ANNEX 6

Letter of Prof. A Schleiss and Dr G. de Cesare, December 22, 2006

Re: Baglihar Hydroelectric Plant - Assessment of reservoir sedimentation and its effects on the power intake, the pondage, and the upstream flood safety.

Baglihar Hydropower Project - Sedimentation Expertise

Figure 4.8 Government of India. Rejoinder, Volume II, March 20, 2006, p26

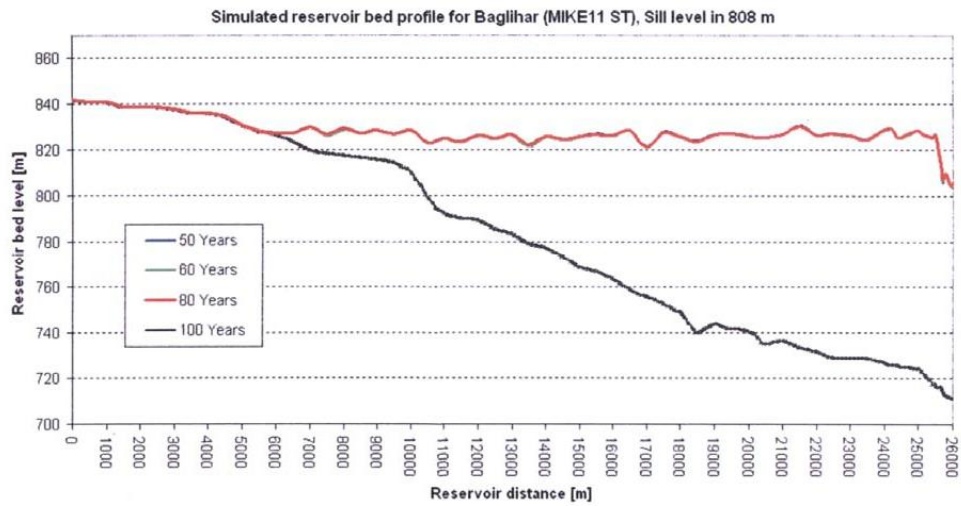
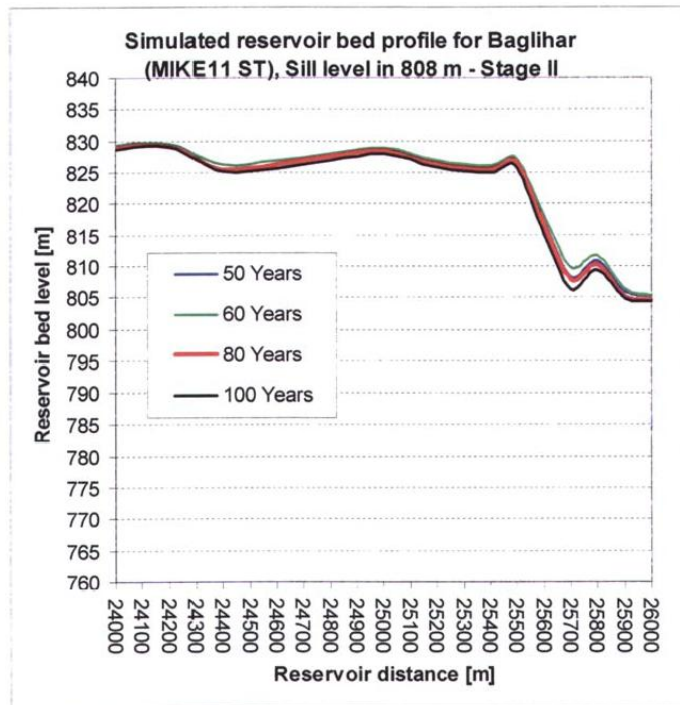
After complete impounding of the reservoir (Figures 4.8 and 4.9 of the Rejoinder, Volume II, attached) the river bed level starts at the dam axis, at 808 m asl (the sill level of the sluice gates), then increases slowly up to 810 m asl, 300 m upstream, reaching about 827 m asl some 500 m from the dam axis. At the entrance to the reservoir, the river bed level remains at the fixed level of 840 m asl. The equilibrium slope of the new river bed formed inside the reservoir, according to Figures 4.8, is very small, almost horizontal; it increases by only a few meters along the whole length of the reservoir.

The result of the analysis in the near field of the dam, the first 300 m, is very questionable. The sluicing with a drawdown which is not lower than 835 m asl will generally not allow for a scouring effect of the sediment for a sufficient length upstream of the dam axis to protect the power intake, and to preserve the pondage.

With the new river bed level near the dam at 827 m asl, and above 840 m asl at the entrance, the answers to the first two questions a) and b) are negative, and c) is not conclusive:

- The pondage of 37.5 M.m³ will be reduced; according to India⁴ the final sustainable volume will be 12 M.m³
- The water intake, which has its sill level at 818 m asl, i.e. lower than the new river bed in this zone, (about 827 m asl) will be flooded by the bed load sediments and the suspended sediment will enter the power tunnel.
- As some of the inputs and results of the Indian calculations concerning impounding of the reservoir are questionable, especially the length scale, it is not certain whether the river bed level at the entrance to the reservoir will increase higher than 840 m asl or not, with the risk of submergence of the town of Pul Doda.

Figure A-14 of the Government of the Pakistani Reply to the Counter Memorial by Government of India, Part I, January 25, 2006, Annex I-A, p20

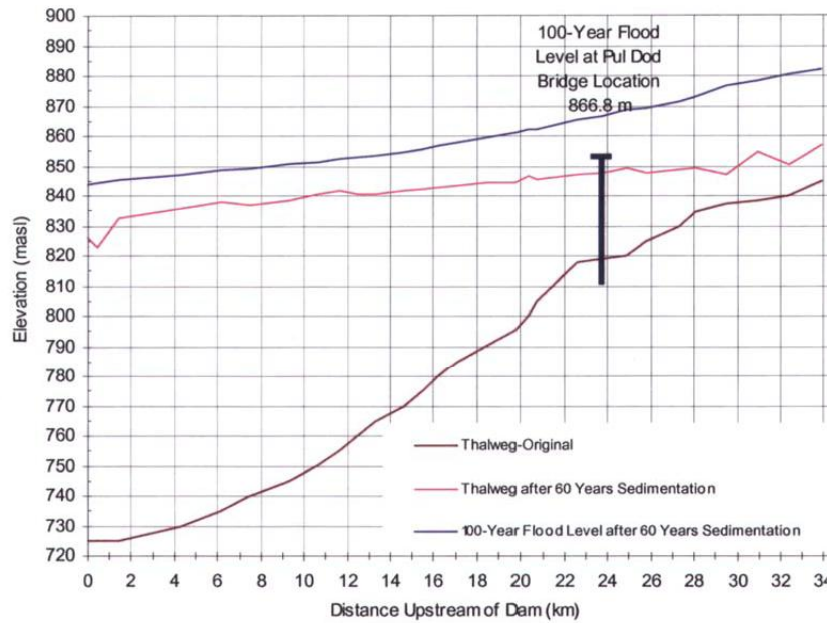
2.3 But before the analysis done by India in its Rejoinder of March 2006, Pakistan presented in its Reply⁵, in January 2006, a numerical analysis with a 1 D model (HEC6-KC-1D) of the filling of the reservoir. It shows (Figure A-14 attached) that after 60 years of sedimentation, the river bed level 1.5 km upstream of the dam will be at 832 m asl, 850 m asl at a distance of some 28 km, and at 858 m asl. at the reservoir entrance. The 100 year flood elevation will rise to 867 m asl at the bridge location and the town of Pul Doda will be inundated⁶. We note that the equilibrium slope of the new river bed for a length of 28 km within the reservoir is about 0.08 %, according to Figure A-14.

⁶ A large ambiguity appears in the analysis done by Pakistan. In Annex IA of the Reply, p1, the gates sill level is indicated at 808 m asl, as in the Indian design, but in Figure A-14, p 20, the river bed level at the dam axis, after 60 years, is at about 825 m asl, which would be the case for a gate sill at 825.60 m asl of the chute spillway proposed by Pakistan. So the reservoir sedimentation would be as stated in Pakistan's design. A rough correction, for a sill at 808 m asl, will give a river bed level of about the same value as stated by India, i.e., 827m asl. But the important result which remains valid is the river bed equilibrium slope of ~0.08 %.

- The mean value of the initial slope of the river bed, between the dam axis and the entrance, is 0.38 %. The final equilibrium bed slope found in the numerical model of Pakistan (~0.08 %) is some five times lower than the initial slope bed slope. This means that in its initial stage, the Chenab River is in a state of degradation; there is a tendency for the bed slope to be reduced by backward erosion, starting at some fixed point on the river bed.

Figure A-15 of the Government of the Pakistani Reply to the Counter Memorial by Government of India, Part I, January 25, 2006, Annex I-A, p21,
Scenario-1: FPL 820 m asl.; Scenario-2: FPL 810 m asl.; Scenario-3: FPL 800 m asl.

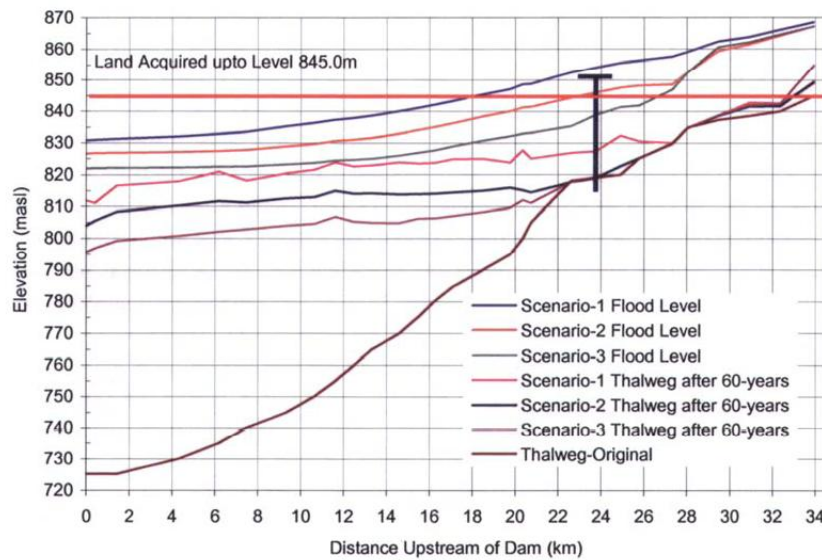
The sedimentation of the reservoir over 60 years was calculated for three scenarios of Full Pond Level (FPL) elevations (820, 810, 800 m asl.). For the first, 820 m asl, which is close to the reservoir levels prescribed during the operations of drawdown-sluicing mentioned under 3.5 (818.5 and 822.0 m asl) the result of the analysis¹⁰ (Figure A-15) is that the river bed level at the bridge will increase by about 8 m (from 819 m asl to 827 m asl). For a 100-year flood of about 8100 m³/s, the water level at the bridge will rise to 854 m asl, while the bridge deck is located at el. 851 m asl. The risk of Pul Doda flooding is real. But if we consider the second scenario, with the reservoir level at 810 m asl, the safety against flooding is approximately fulfilled. This result calls into question the sill level of the gates, which is probably not sufficiently low.

As for the question c) concerning the protection of the town of Pul Doda, some calculations indicate that the protection against flooding would not be ensured. We consider that the situation could be safe with the sill level of the sluice gates lower, at about el. 800 m asl.
